ESHID-603647

Subject: Response to Administratively Incomplete Determination Part A and General Part B of the Resource Conservation and Recovery Act (RCRA) Permit Renewal Application Los Alamos National Laboratory EPA ID#NM0890010515, HWB-LANL-20-001

**Response to Administratively Incomplete
Determination Part A and General Part B of the
RCRA Permit Renewal Application Los Alamos
National Laboratory EPA ID#NM0890010515,
HWB-LANL-20-001**

Attachment 5
5-Year Averaged Wind Roses for Day and Night at LANL (2016-2020)

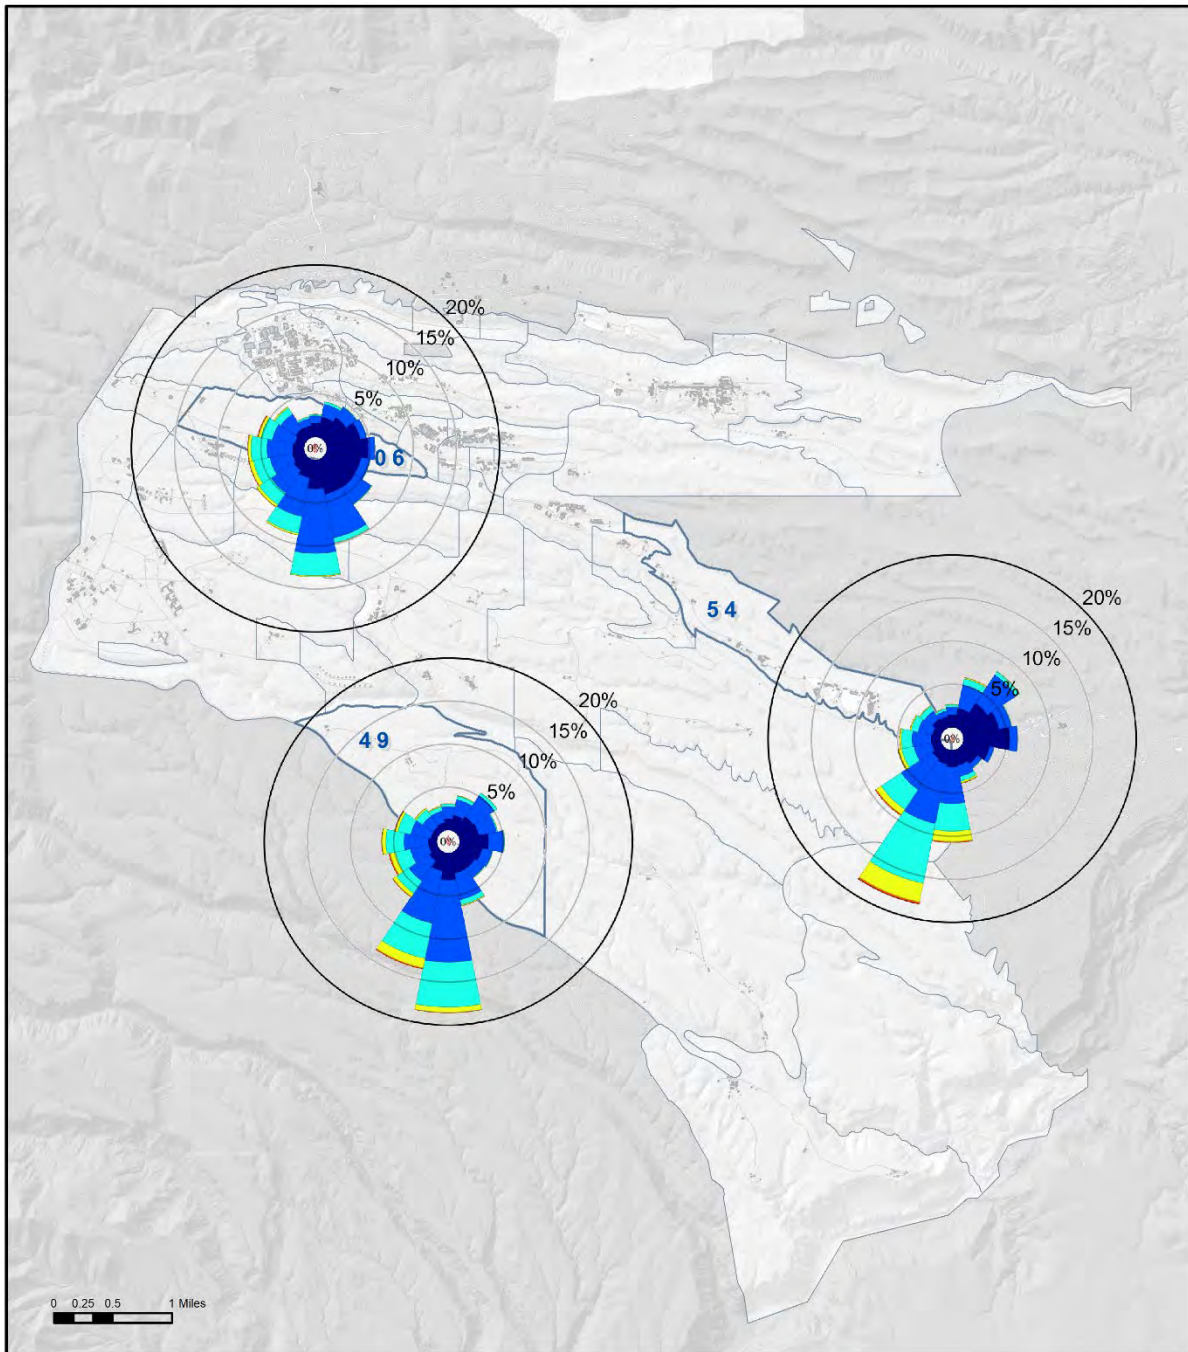
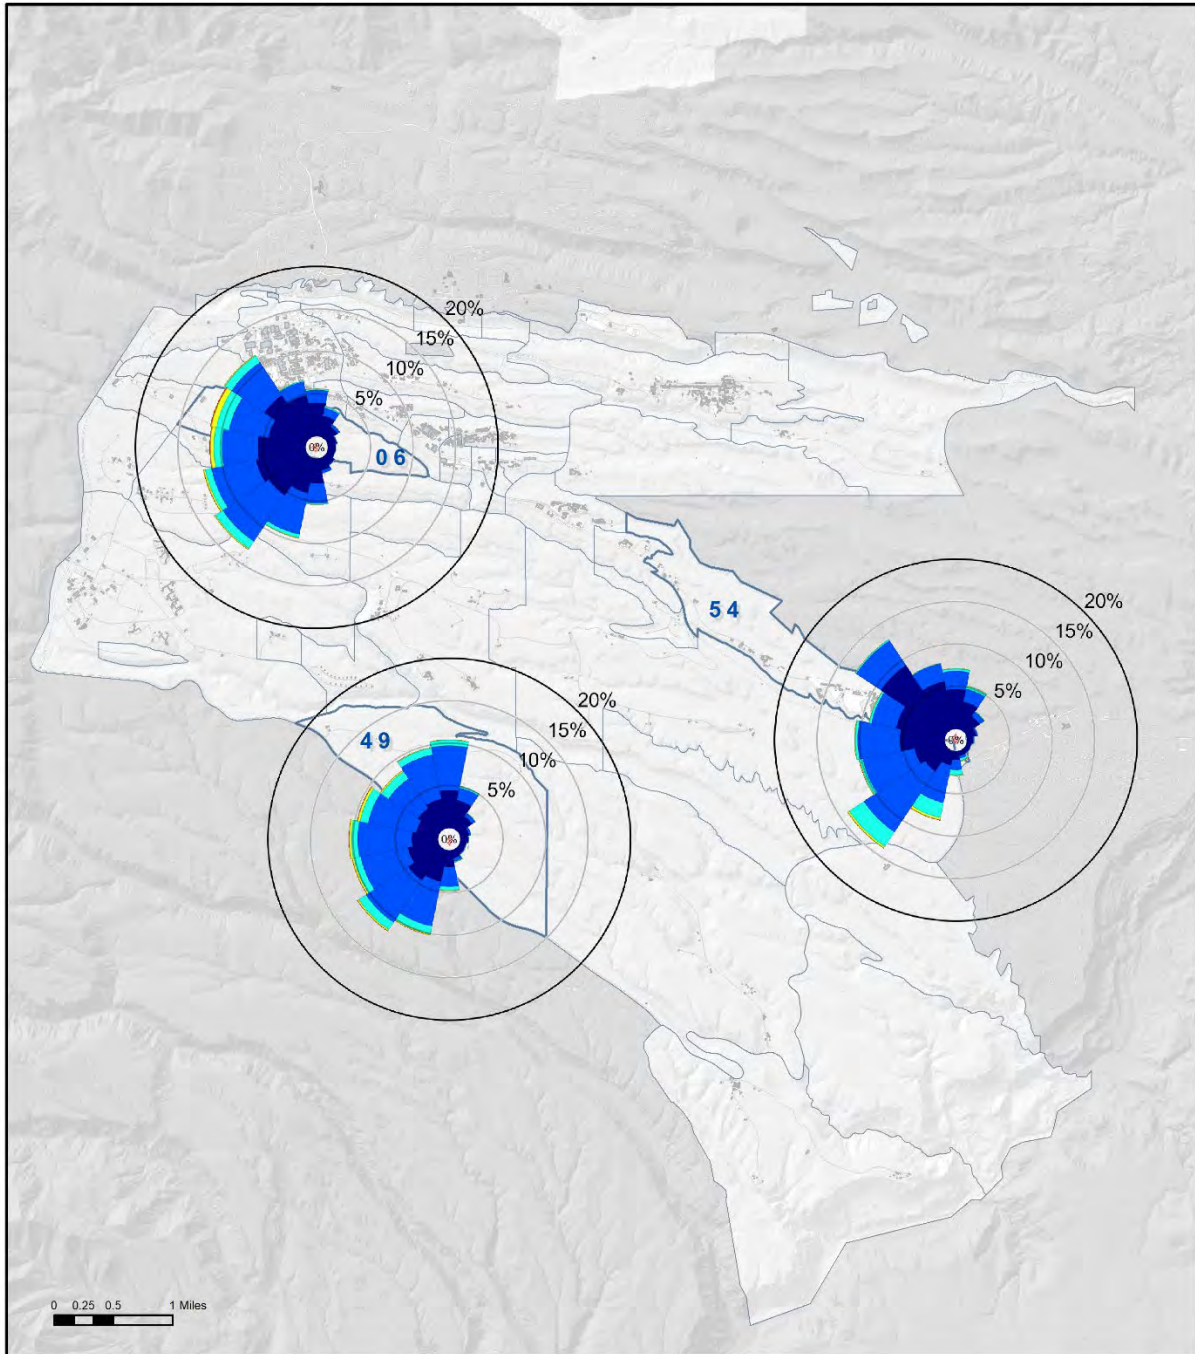
7. Section 2, Figure 2-3 Wind Roses (Day and Night), page 2-24:

- Attachment 5 includes 5-year average wind roses for day and night over the years 2016 through 2020.
- Attachment 6 includes a revised Supplement 1-1, *Permittees' Proposed Changes to Permit Parts 1-11*, for replacement in the Permittees' Permit Renewal Application.
